**RE: Safety Counseling Office
2900 Wellesley NE
Grading & Drainage Plan
Engineer's Stamp Date: 04/12/23
Hydrology File: H16D101**

DRAINAGE AND TRANSPORTATION INFORMATION SHEET (REV 10/2018)

GRADING AND DRAINAGE PLAN

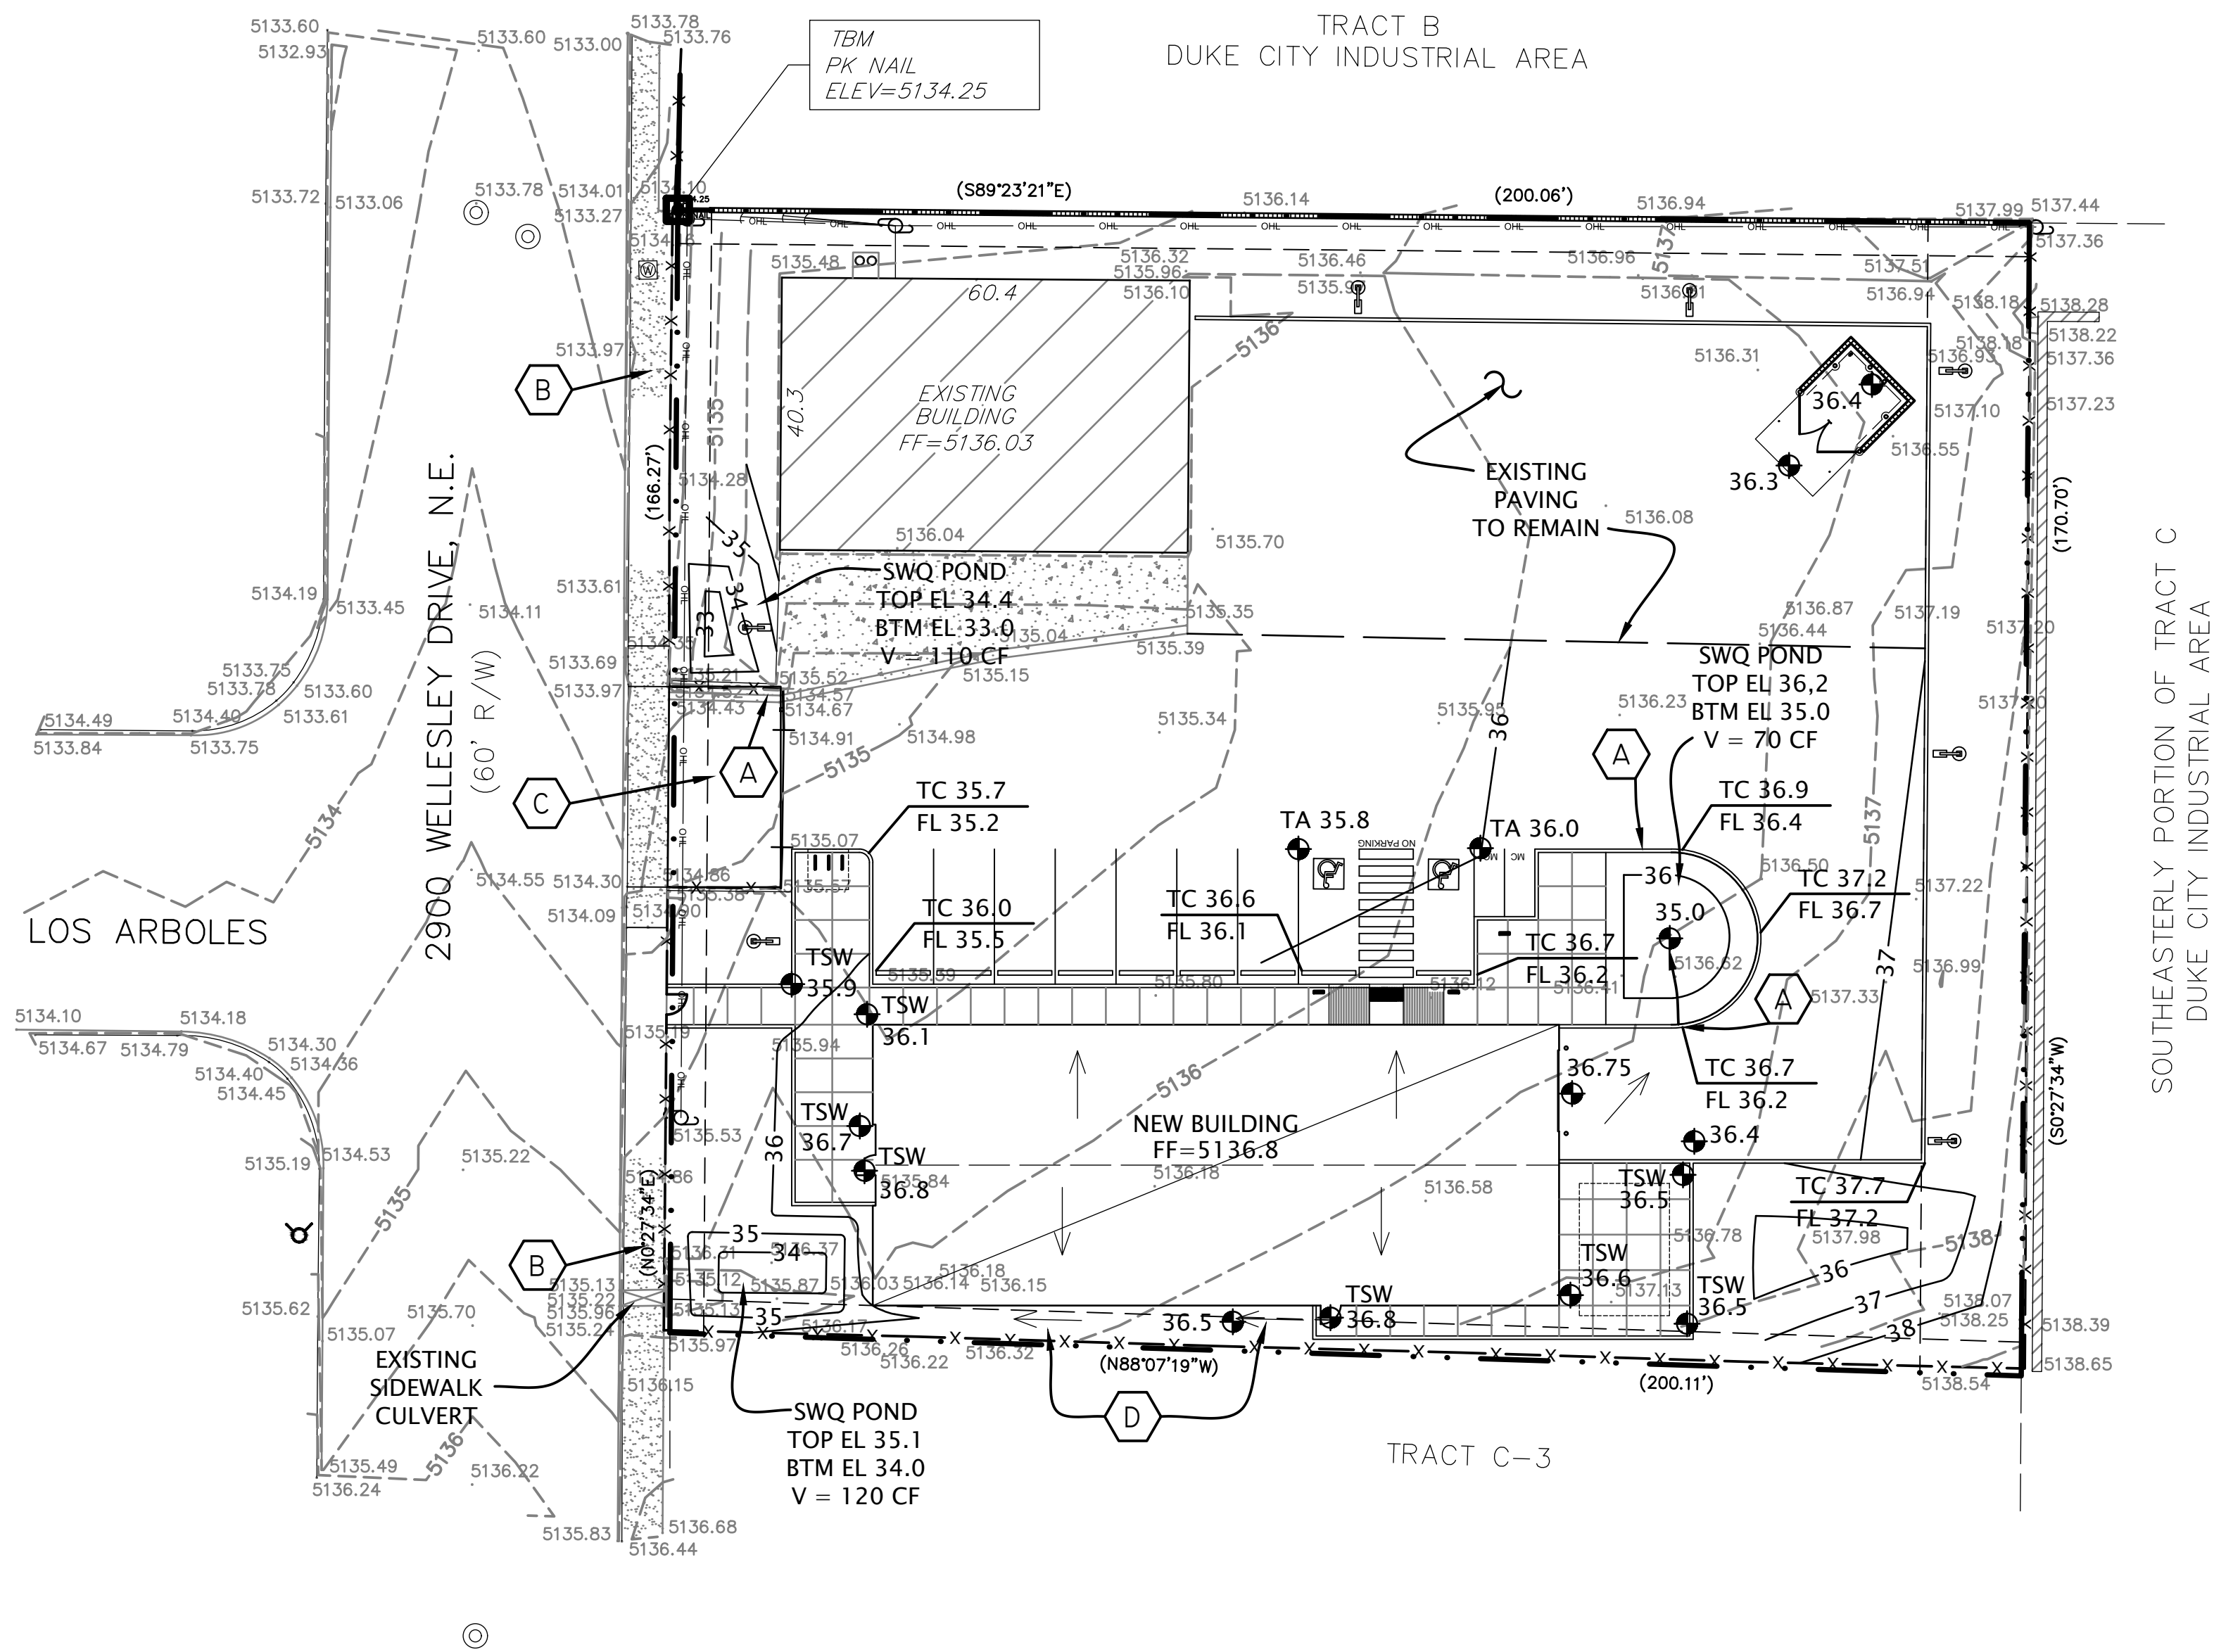
Based upon the information provided in your submittal received 04/28/2023, the Grading & Drainage Plan is approved for Building Permit. Please attach a copy of this approved plan in the construction sets for Building Permit processing along with a copy of this letter.

1. Engineer's Certification, per the DPM Part 6-14 (F): *Engineer's Certification Checklist For Non-Subdivision* is required.
2. Please provide the executed paper Drainage Covenant (latest revision) printed on one-side only with Exhibit A and a check for **\$25.00** made out to "**Bernalillo County**" for the stormwater quality ponds per Article 6-15(C) of the DPM to Hydrology for review at Plaza de Sol.
